Re; Demolition of existing cottage and new bungalow at Fairview,
Celbridge Road, Lucan. Reg.Ref. 91A/1606

Register Reference : 91A/1606

Development : Demolish existing cottage and to replace it with a new bungalow

LOCATION : Fairview, Celbridge Rd, Lucan

LOCATION MAP. SCALE: 1/2500

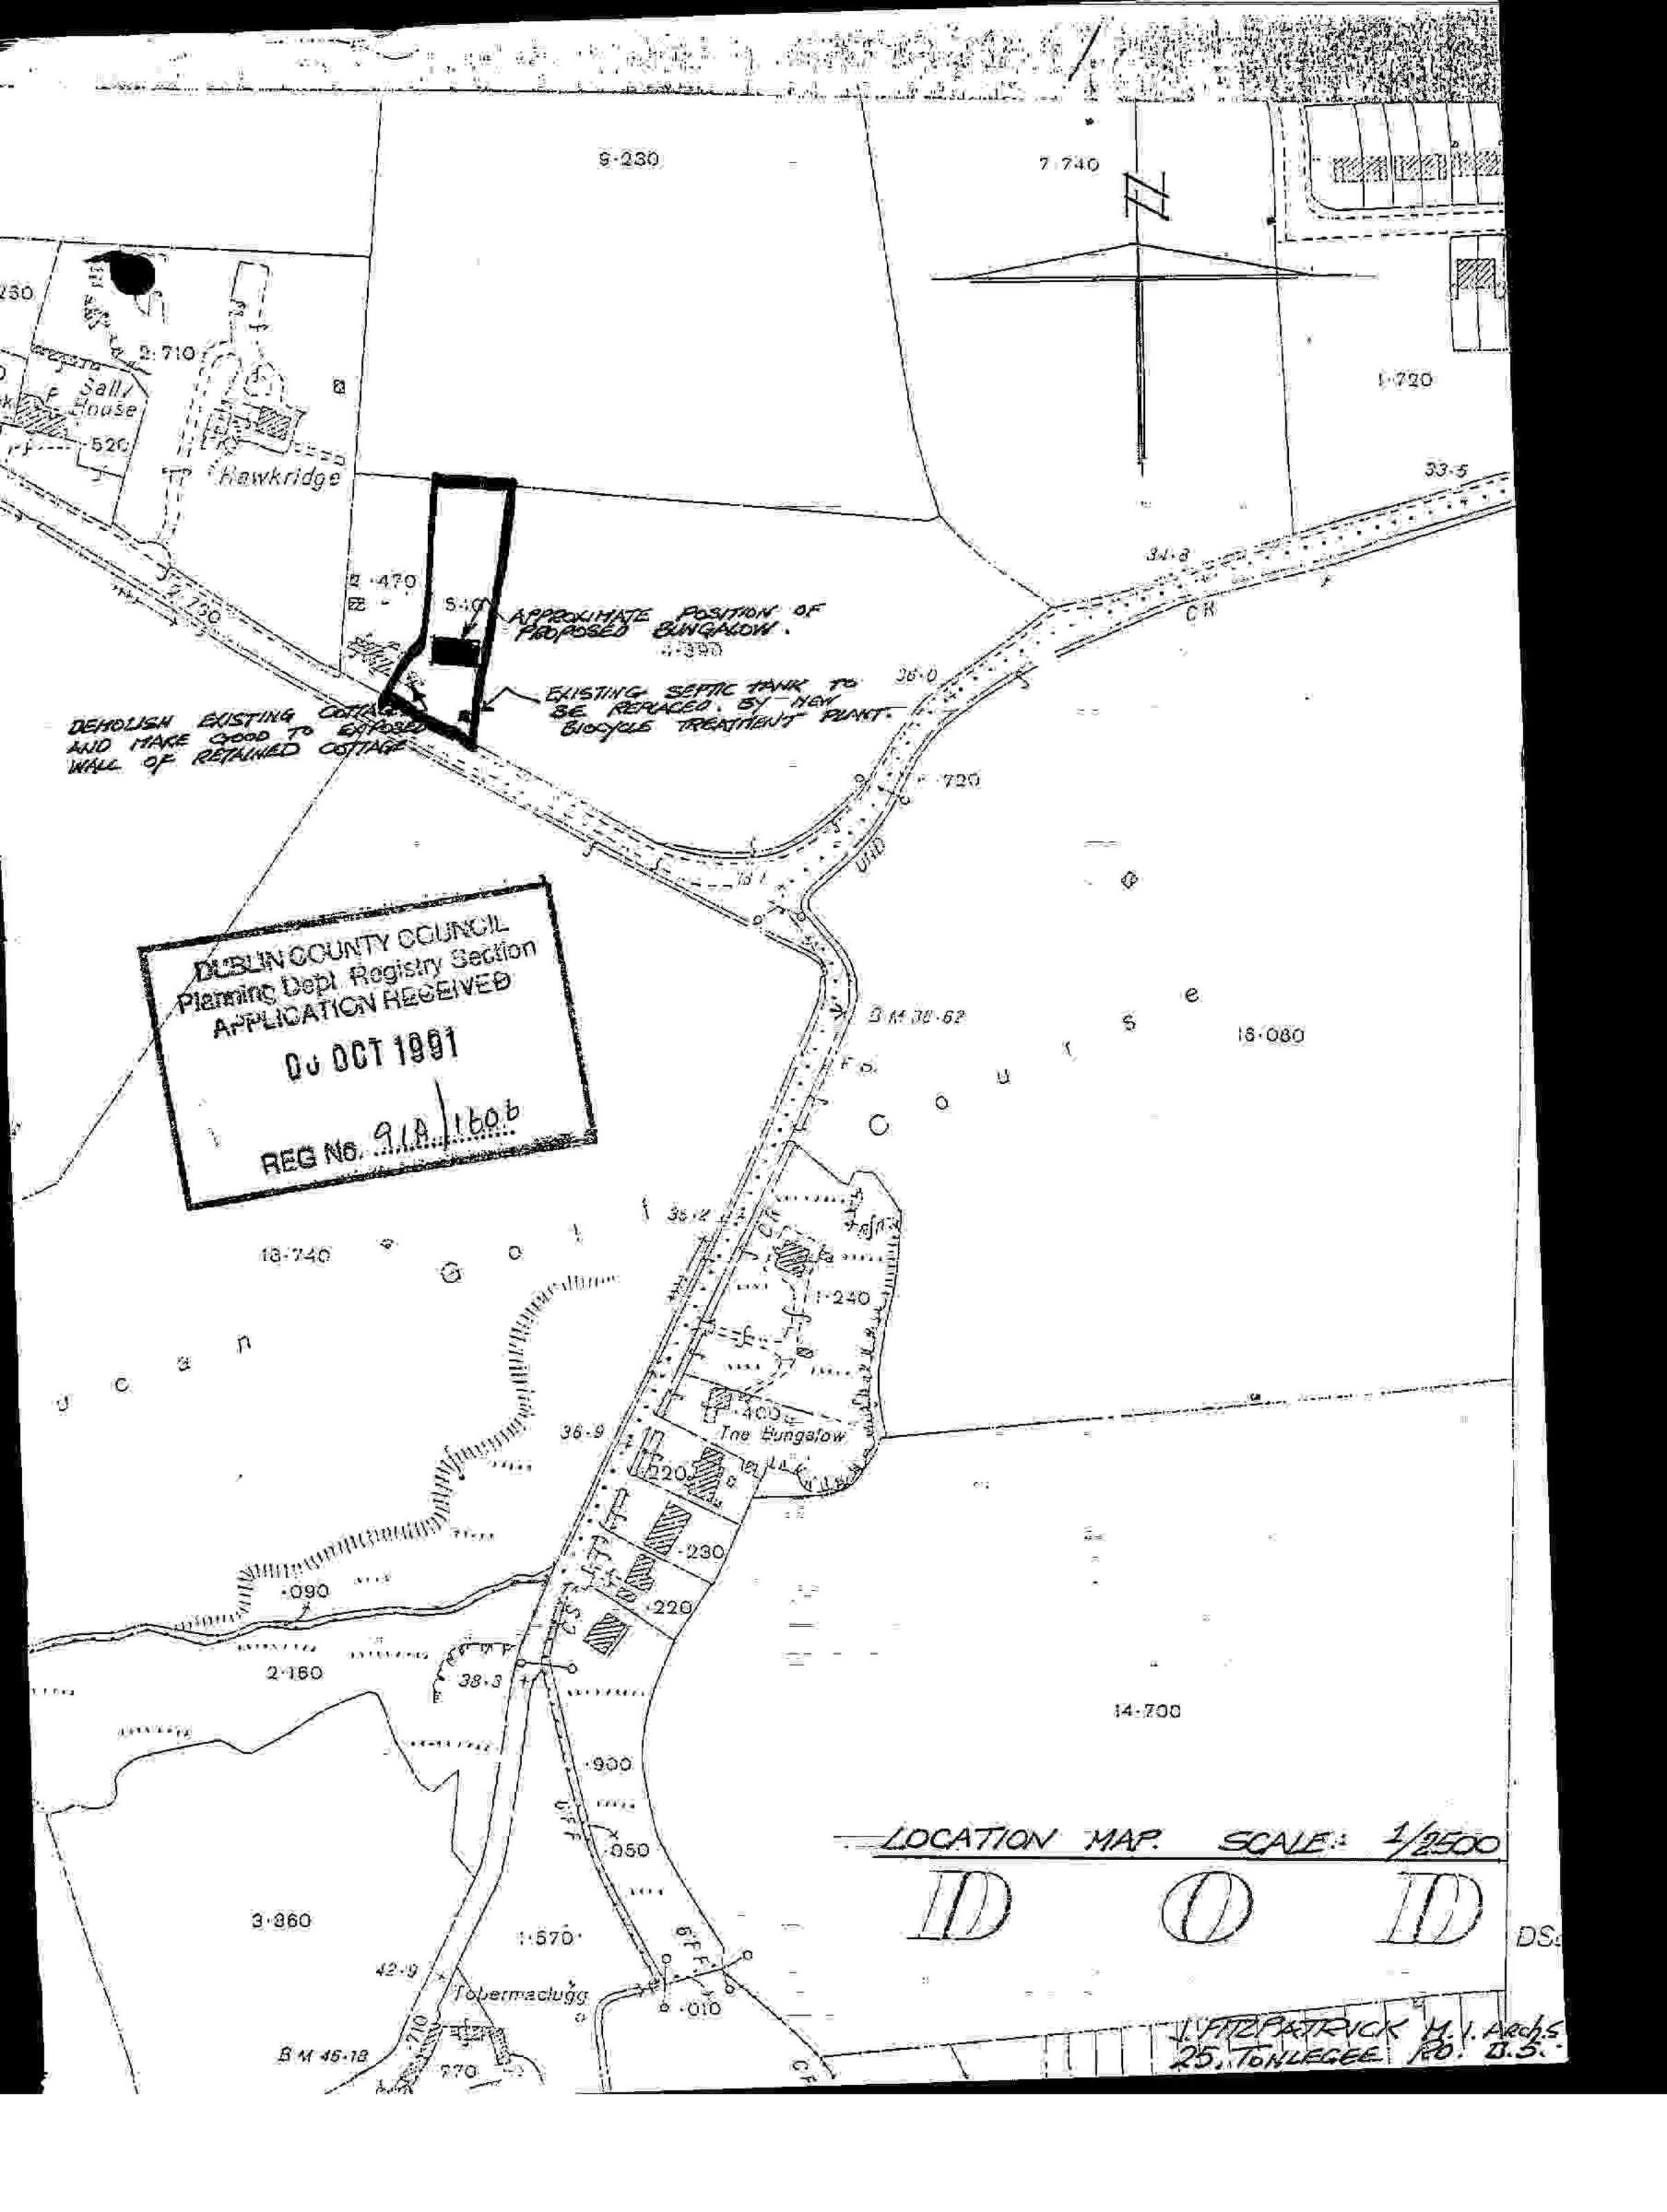
~~The existing cottage to be removed is not shown accurately on the site plan.~~
Lodged plans provide for the replacement of an existing septic tank to the front of the site with a biocycle treatment plant. No further details of this system have been submitted.

- a. There is no evidence to indicate soil suitability for the treatment and disposal of effluent from the waste water treatment system.
- b. No details/specifications of the proposed waste water treatment system submitted.
- c. No details and location of proposed irrigation system for disposal of effluent indicated.
- d. Distance of treatment plan from proposed and existing dwellings not indicated.

- e. Location of adjoining septic tank drainage system and percolation areas/soak pits not indicated.

The applicant is requested to submit a revised block plan of site not less than 1:500. This should identify accurately the existing cottage to be demolished, all adjoining buildings and the location of the proposed bungalow.
